Ref: 2022/4794/P and 2023/0106/L

1. This is a further letter to raise concerns and object to the excavation of the studio building at the rear of 28 Charlotte Street London.

Proposed excavation of Artist Studio at Rear of 28 Charlotte Street seen from 7 – 15 Whitfield Street development.

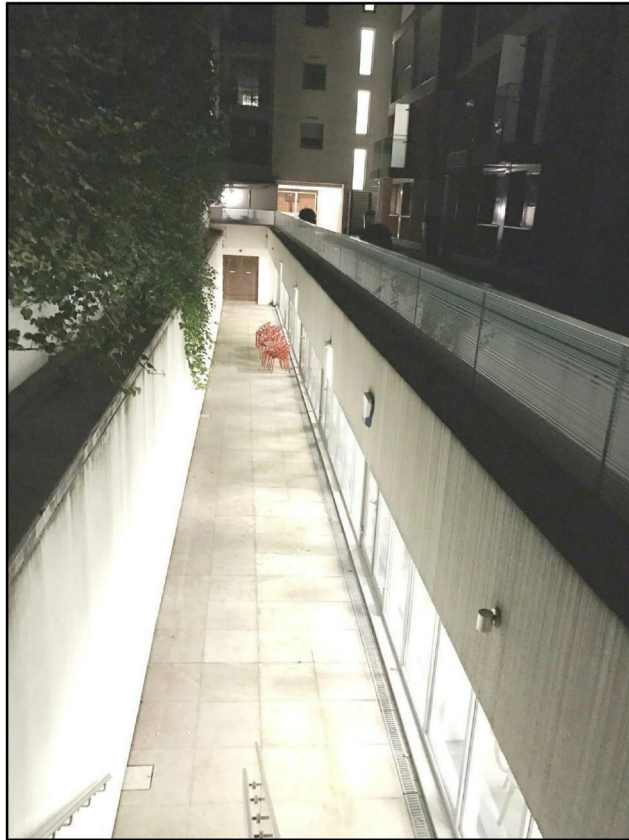
The buttress on the corner marked with a **GREEN X** of the studio building at 28 Charlotte St shown in brown brick supports the entire studio building. No mention in planning application on how that will be supported or dealt with in the excavation.

The **red circle** shows some of the cracks on the studio wall.

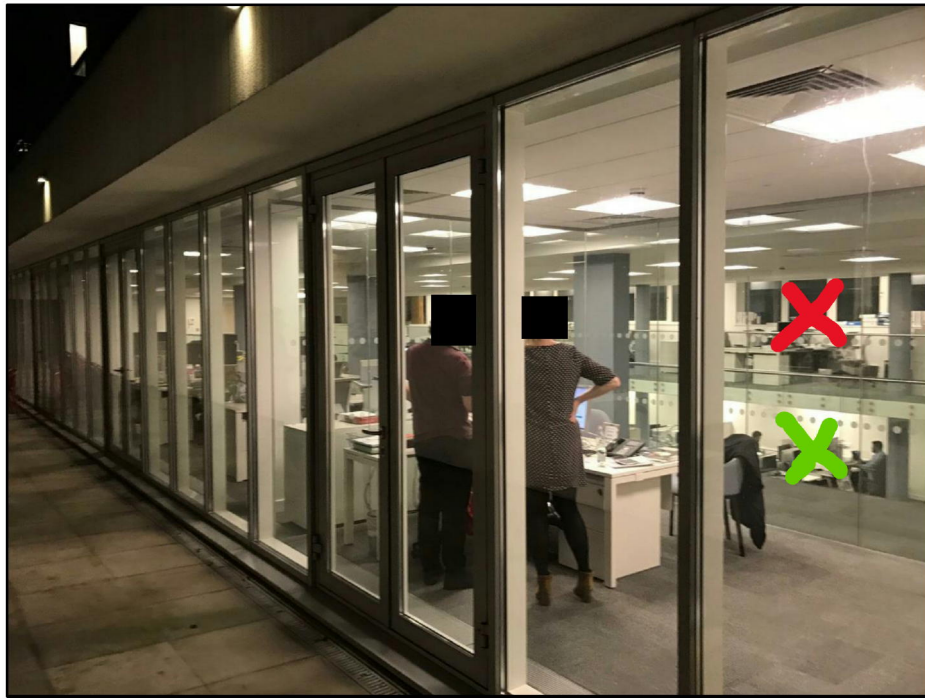
The office basement is 7 metres from the proposed excavation of the studio at 28 Charlotte Street.

7 – 15 Whitfield Street development has an extensive office two level basement below its flats and houses. This basement and its plant room butt onto the proposed development wall and proposed basement excavation.

Photo plant room of the basement offices of 7 -15 Whitfield Street Development marked **GREEN X.**

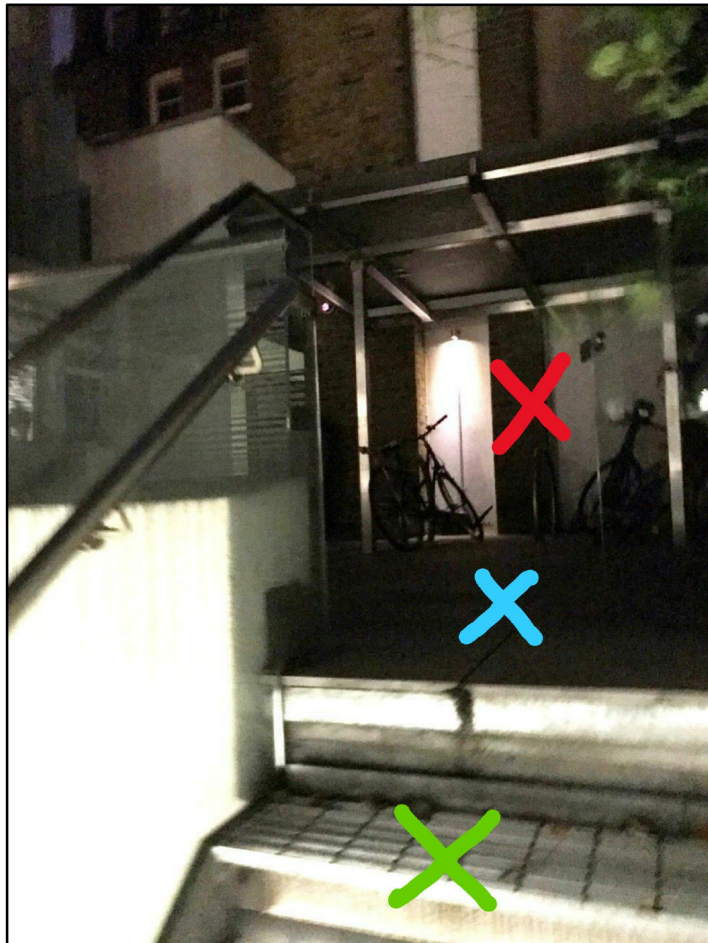
These plant room services have not been considered in the basement excavation as they are abutting the party wall.

The plant room which runs to the end of the party wall to the proposed excavation of the studio at 28 Charlotte Street. No indication has been provided regarding the extent of the basement excavation and its relationship with respect to the services in the plant room which runs to the party wall.
